Randwick Local Planning Panel (Electronic) Meeting

Thursday 24 October 2024

Development Application Report No. D86/24

Subject: 80 Doncaster Avenue, Kensington (DA/799/2024)

Figure 43: 2nd floor plan (Source: Burrow Architecture)
Marked up by Council Assessment Officer

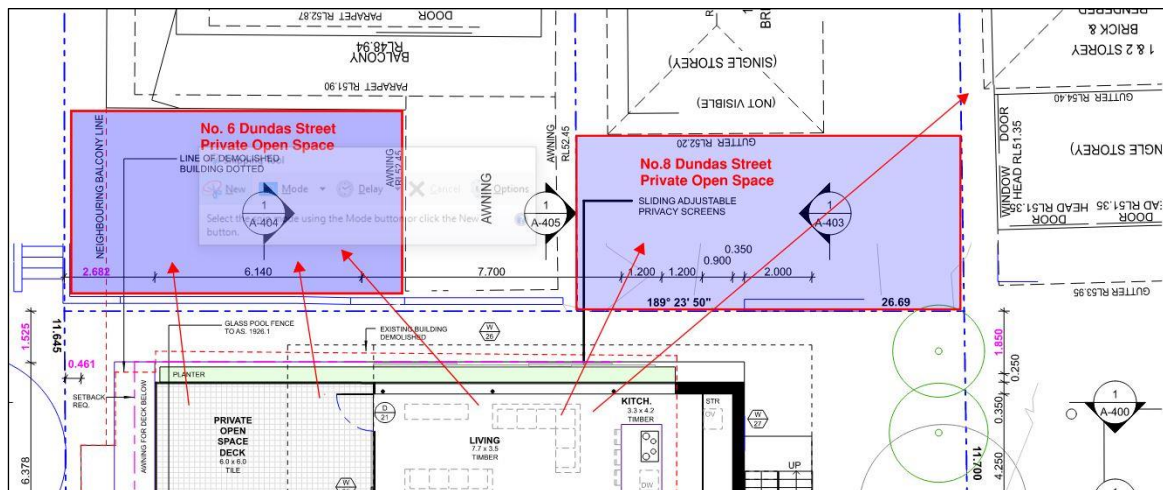
One of the consequences of the non-compliant four-storey proposal is the creation of elevated high-intensity use living spaces that overlook neighbouring dwellings. The proposed 2nd floor 'private open space deck' will directly overlook the private open space of No.6 Dundas Street. The 2nd floor living area has sliding glazing across the entire eastern elevation with adjustable privacy screens as the only privacy mitigation measure. These windows will enable overlooking into the private open space of both No.6 & No.8 Dundas Street (refer Figure 43 & 44). It may also be possible to look into the windows of habitable spaces of No.6, No.8 and No.10 Dundas Street.

Figure 45: Lower ground floor plan (Source: Burrow Architecture)

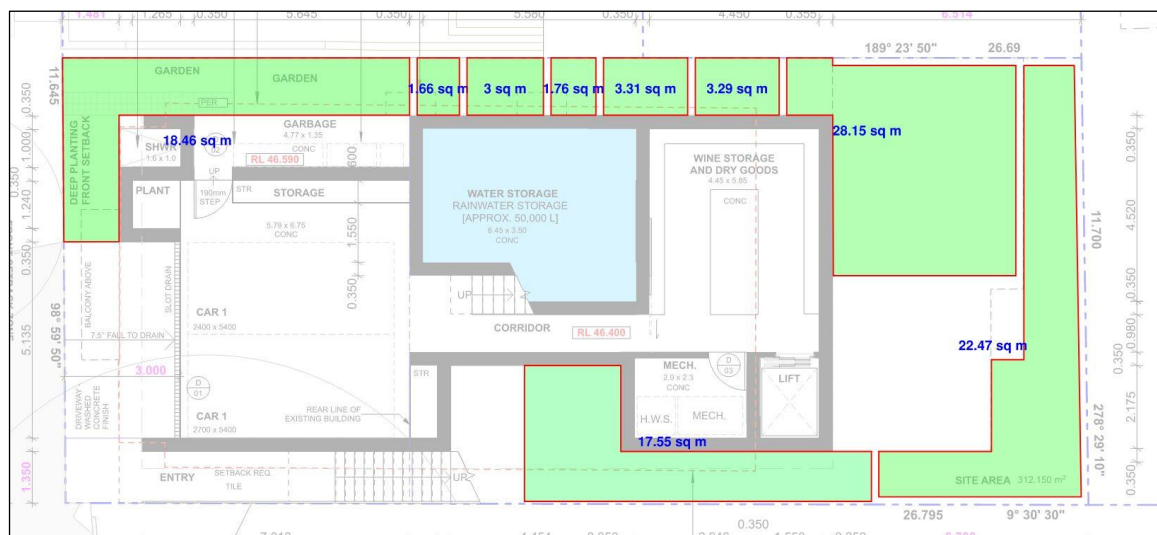
Pursuant to Part C1, Section 2.5 of the DCP, the proposal is required to provide 35% deep soil permeable surface. The deep soil has been measured from the scaled drawings to be 99.65m² which equates to 32% of the 312.15m² site area (refer Figure 45).
